CITY OF ALBUQUERQUE

Re: Inspire Salon
3100 Monte Vista Blvd.
Traffic Circulation Layout
Engineer's/Architect's Stamp XX-XX-XX (K16-D087)

Based upon the information provided in your submittal received 02-08-17, the above referenced plan cannot be approved for Building Permit until the following comments are addressed:

TRAFFIC CIRCULATION LAYOUT
1" = 10'-0"

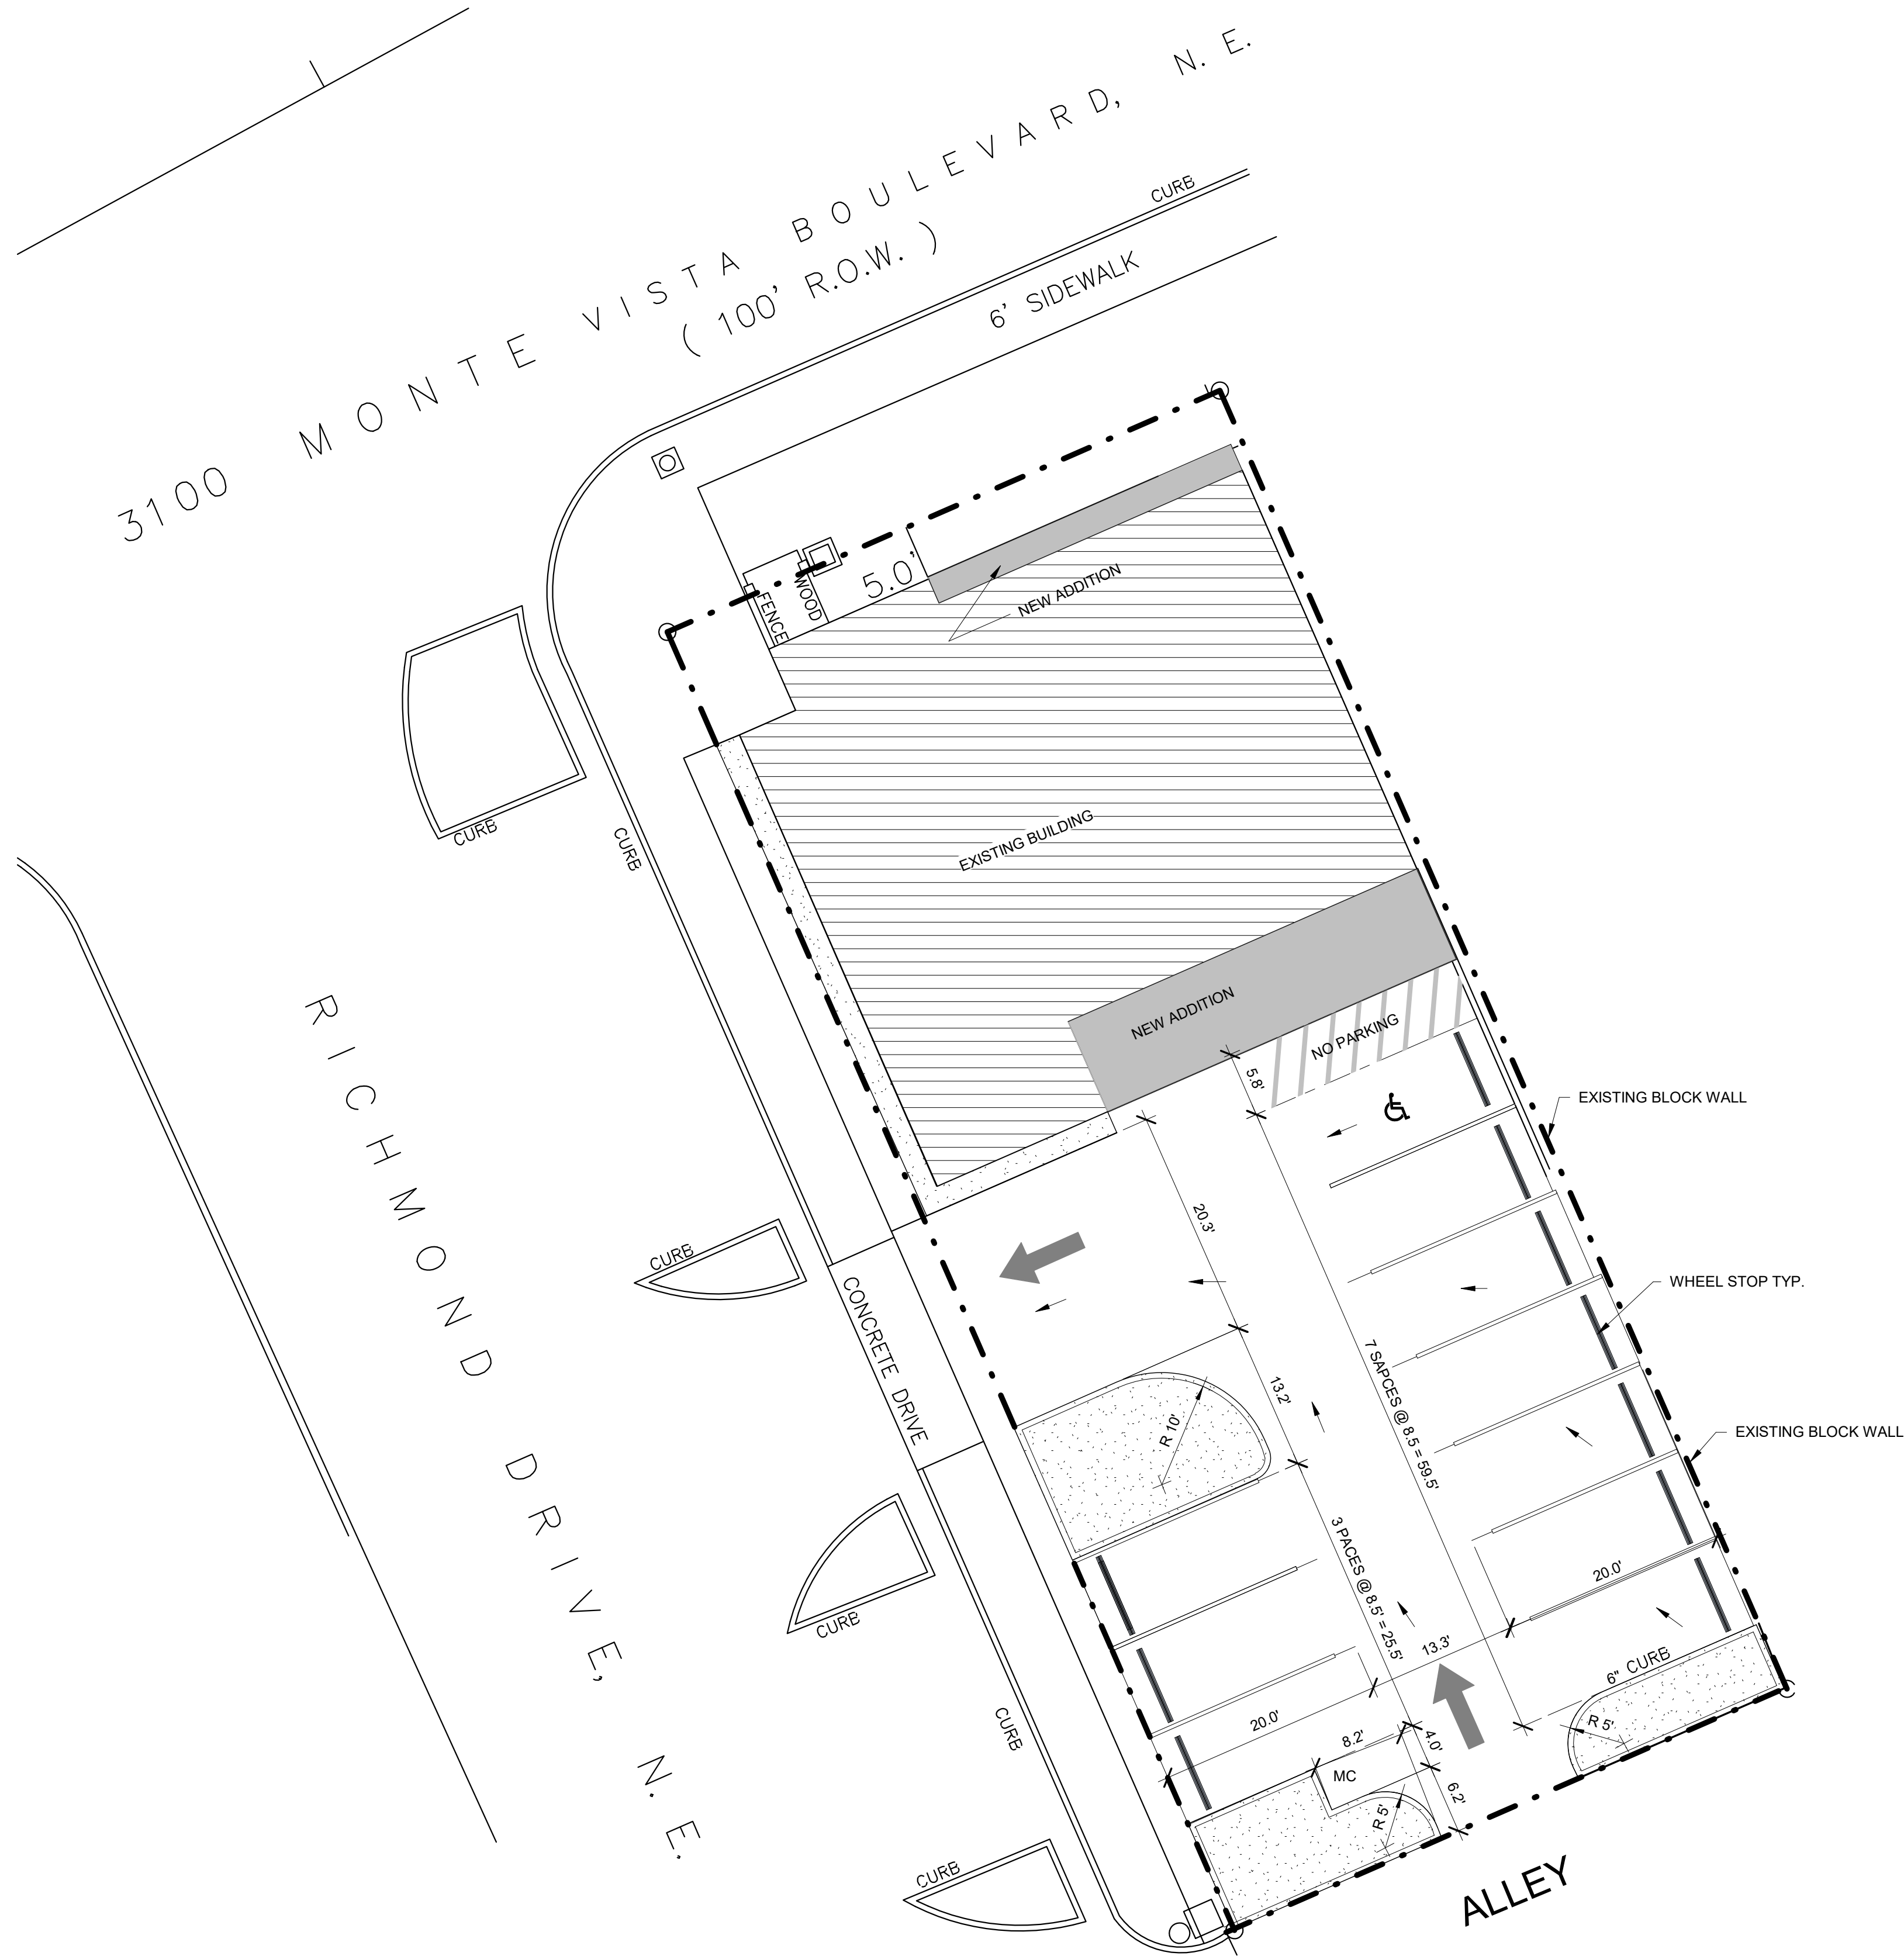
1. The traffic circulation layout must be stamped, signed, and dated by an engineer or architect licensed in the state of New Mexico.
2. Identify the right of way width, medians, curb cuts, and street widths on Richmond and the alley. Also please indicate the alley surface condition.

3. The handicap accessible spaces must include an access aisle. Van accessible aisles should be 8ft wide; all others should be 5ft wide.
4. The ADA accessible parking sign must have the required language per 66-7-352.4C NMSA 1978 **"Violators Are Subject to a Fine and/or Towing."** Please call out detail and location of HC signs.

5. The ADA access aisles shall have the words **"NO PARKING"** in capital letters, each of which shall be at least one foot high and at least two inches wide, placed at the rear of the parking space so as to be close to where an adjacent vehicle's rear tire would be placed. (66-1-4.1.B NMSA 1978)

6. One-way vehicular paths require pavement directional signage and a posted **"Do Not Enter"** sign at the point of egress. Please show detail and location of posted signs.

7. It is not apparent what type of pavement surface is being proposed. A hard driving surface will be required as part of this proposed project for parking area and drive aisles.

8. Please show the location of the bike rack and motorcycle sign on the plan.
9. Please indicate the number of proposed parking spots on the parking calculations.
